**DOMINION ENERGY SOUTH CAROLINA, INC.**  
**VIRGIL C. SUMMER NUCLEAR STATION UNIT 1**  
**LICENSE AMENDMENT REQUEST - PROPOSED REVISION TO TECHNICAL**  
**SPECIFICATIONS TO RELOCATE CERTAIN CYCLE-SPECIFIC CORE OPERATING**  
**LIMITS TO THE CORE OPERATING LIMITS REPORT AND INCORPORATION OF**  
**IMPROVED  $F_Q$  METHODOLOGY**

The proposed amendment would revise the Technical Specifications (TS) for VCSNS to relocate certain cycle-specific core operating limits to the Core Operating Limits Report (COLR). The proposed amendment will also revise VCSNS TS to address non-conservatisms in the Heat Flux Hot Channel Factor ( $F_Q$ ) identified by Westinghouse Nuclear Safety Advisory Letter (NSAL) 09-5, Revision 1, and incorporate the NRC-approved Improved  $F_Q$  Methodology in WCAP-17661-P-A as well as other improvements to VCSNS  $F_Q$  TS.

**DESCRIPTION AND ASSESSMENT OF PROPOSED CHANGE – CYCLE-SPECIFIC  
CORE OPERATING LIMITS**

**DESCRIPTION AND ASSESSMENT OF PROPOSED CHANGE – IMPROVED F<sub>Q</sub>**  
**TECHNICAL SPECIFICATION**

Figure 2.1-1  
Reactor Core Safety Limits - Three Loop Operation  
2-2

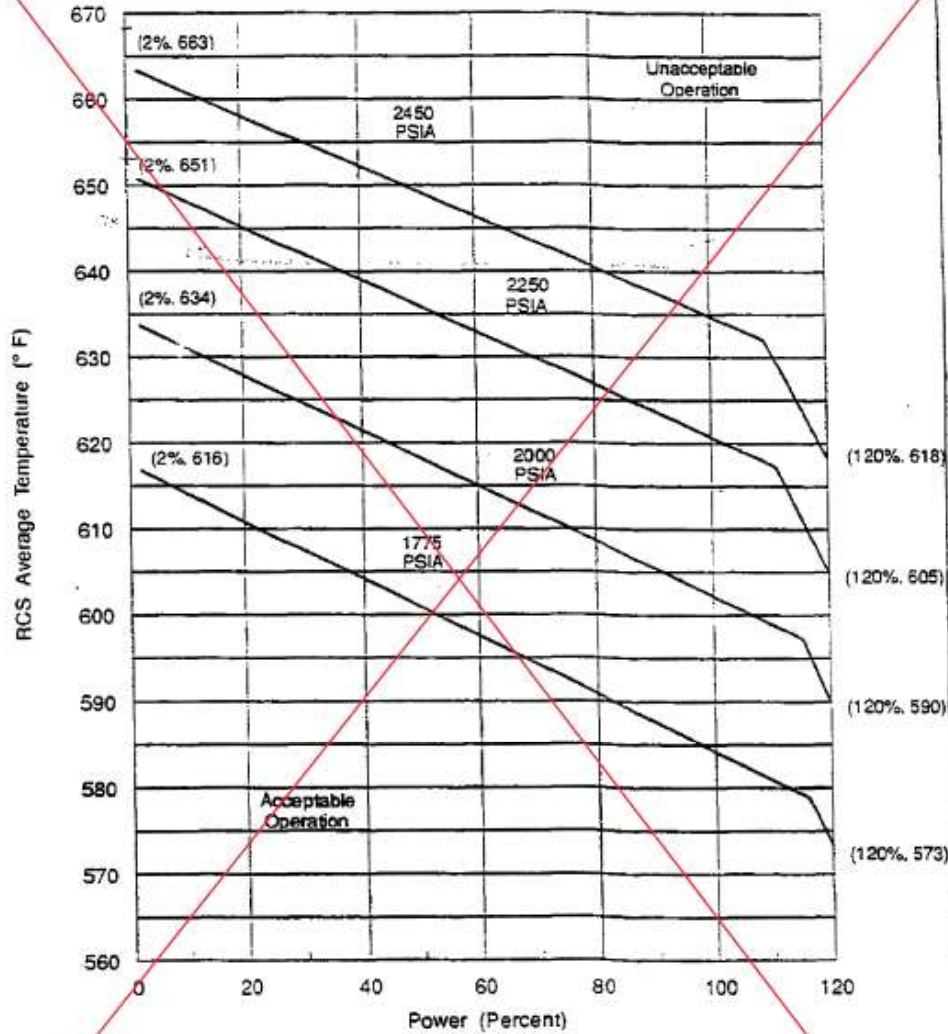
The proposed changes will relocate Figure 2.1-1, “Reactor Core Safety Limits-Three Loop Operation” to the COLR, redirect the reference for Figure 2.1-1 in TS 2.1.1 to the COLR, and add two safety limits: 1) departure from nucleate boiling ratio (DNBR) and 2) peak fuel centerline temperature (as new TS 2.1.1.a and TS 2.1.1.b,

TS Figure 2.1-1, "Reactor Core Safety Limits-Three Loop Operation," will be deleted and replaced with the wording: "THIS PAGE INTENTIONALLY LEFT BLANK."

Delete this figure and replace with wording "THIS PAGE INTENTIONALLY LEFT BLANK"

FIGURE 3.1-3  
REQUIRED SHUTDOWN MARGIN  
(MODES 3, 4, AND 5)

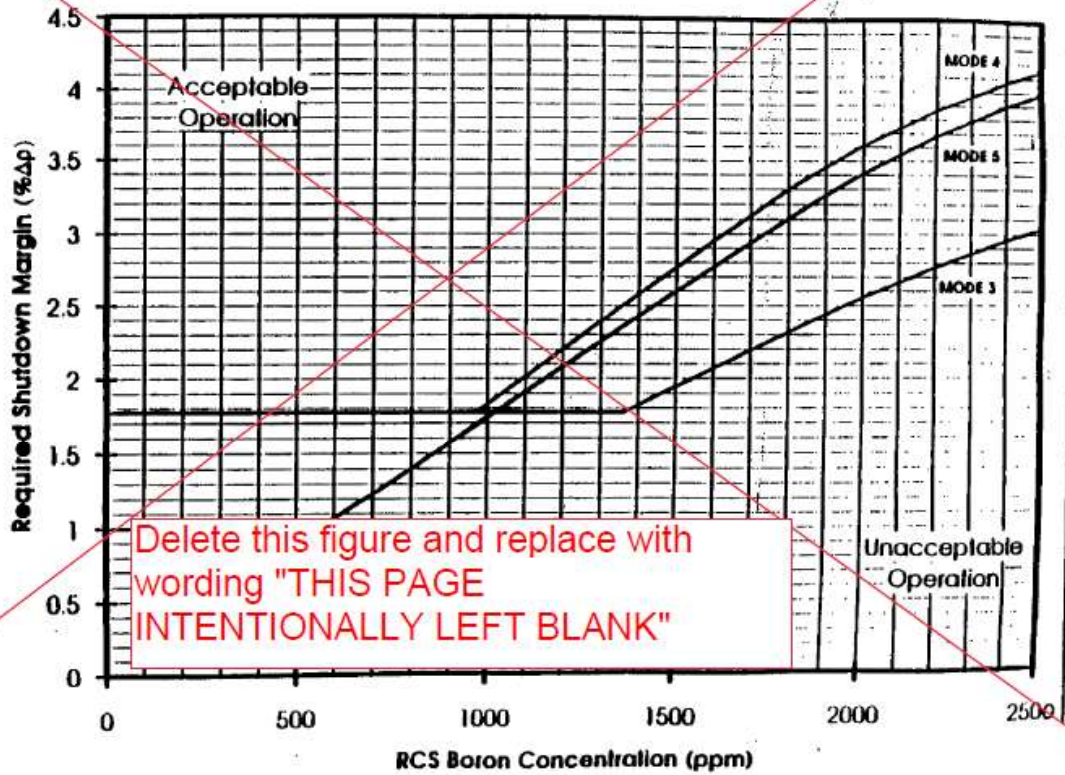
The proposed change will relocate Figure 3.1-3, 'Required Shutdown Margin' and the shutdown margin reference from TS 3.1.1.2 to the COLR. Consequently, affiliated TS Table 3.3-1 ACTION 5 will be reworded. Discrepancy on shutdown margins associated with Actions of TS 3.1.2.2 and TS 3.1.2.6 will also be corrected to reference the COLR for shutdown margin requirement.

TS Figure 3.1-3, “Required Shutdown Margin,” will be deleted and replaced with the wording: “THIS PAGE INTENTIONALLY LEFT BLANK.”

3.1.1.2 The SHUTDOWN MARGIN shall be ~~greater than or equal to the limits shown in Figure 3-1-3.~~
